Planning Commission
NOTICE of PUBLIC HEARING

Notice is hereby given that the Planning Commission of the City of Troy, New York will conduct a public hearing on **Thursday August 16, 2012 at 6:00 P.M.** in the 2nd Floor Conference Room A of City Hall in order to hear and decide on proposals for development as follows:

Staff Report # PC2012-043

Staff Report # PC2012-036

PROPOSED SITE PLAN
SCALE: 1"=20'

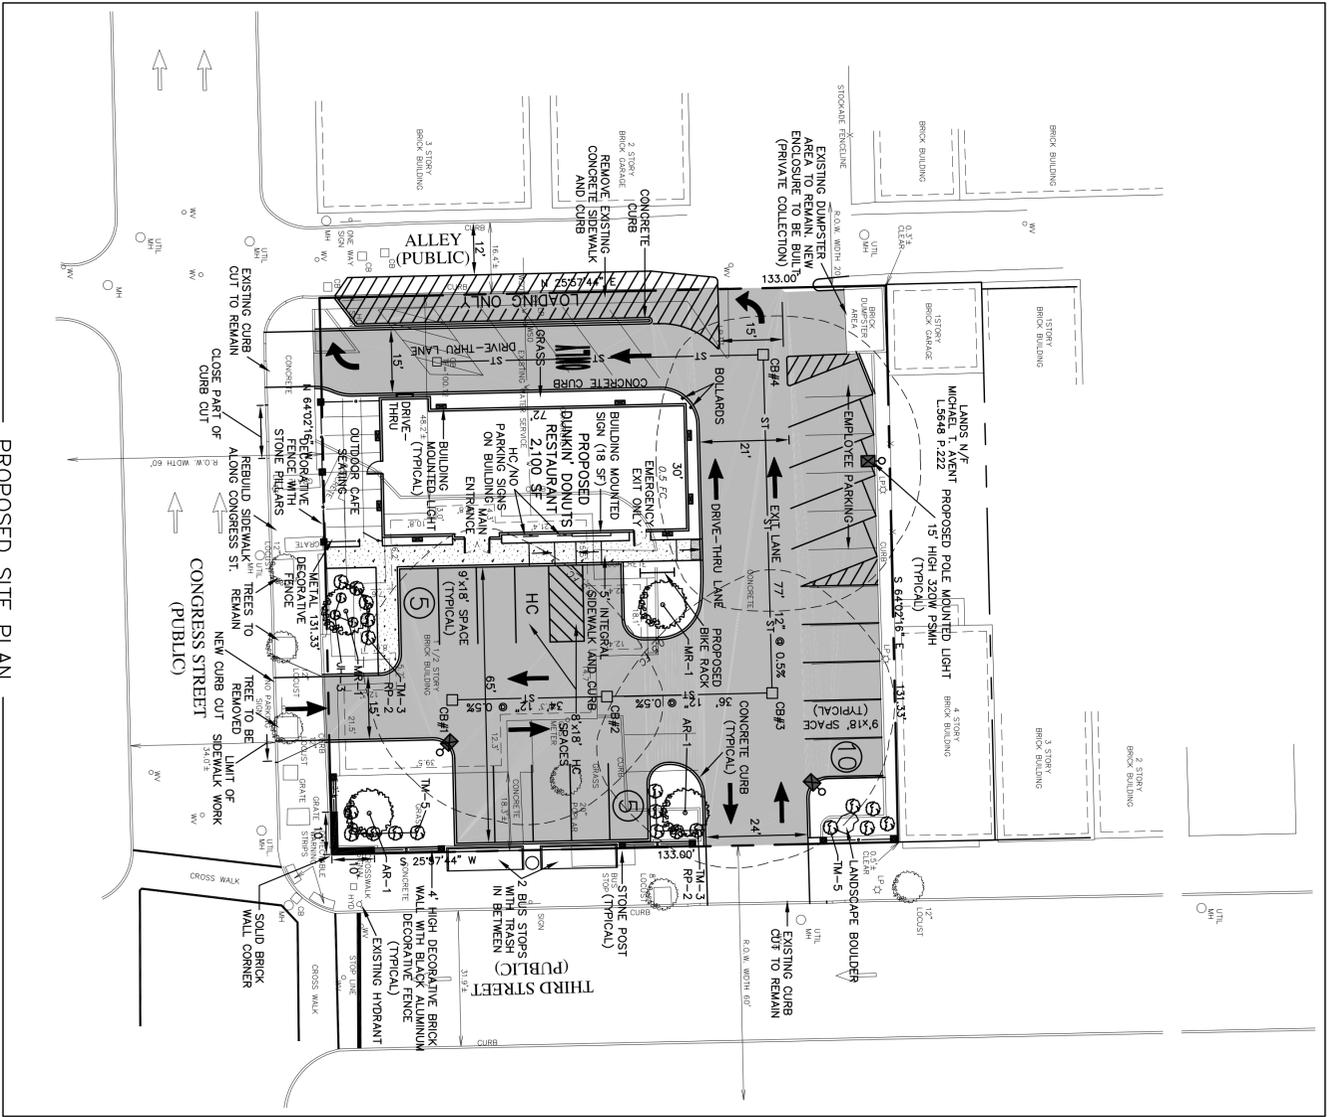
The applicant proposes to demolish an existing drive thru restaurant, and replace with a new drive thru Dunkin Donuts approximately 2100SF.

The applicant proposes 24 off-street parking spaces and one way in access from Congress Street, two way access from 3rd Street into the site and exiting onto Congress Street via drive thru and the service ally

Dumpster location is adjacent to the alley at the rear of the property. Doors are to be installed on existing enclosure.

Applicant proposes exterior dining area affronting Congress Street. The area is to be segregated by an ornamental metal fence with brick accents.

The applicant proposes a brick façade and architectural features to compliment adjacent properties. Building coins to be constructed of brick. Awnings to be provided and signage to be externally lit.

Currently storm water is collected at one catch basin to the western portion of the property. The applicant proposes to extend the line around the building to collect all surfaces run off. Final utility connections to be determined in the field.

A brick wall and fence detail will be constructed on 3rd Street. Signage is to be integrated into wall at corner of lot. Bus stops will be located against the wall. 2 bus stops will be located and 2 outdoor seating areas. Although not a part of the approval, the projects will be integrated.

Applicant will remove curbing between property and alley. A transition stip will be added and striped for delivery trucks only. Applicant will pave alley and install curbing across from alley access from site.

Applicant shall make eastern entry/exit located on Congress Street and entry only. Curb cut for this location should be as far from intersection as possible.

Applicant shall construct a brick fence around property. A combination of brick and metal fence will be required to be reviewed by planning staff prior to installation.
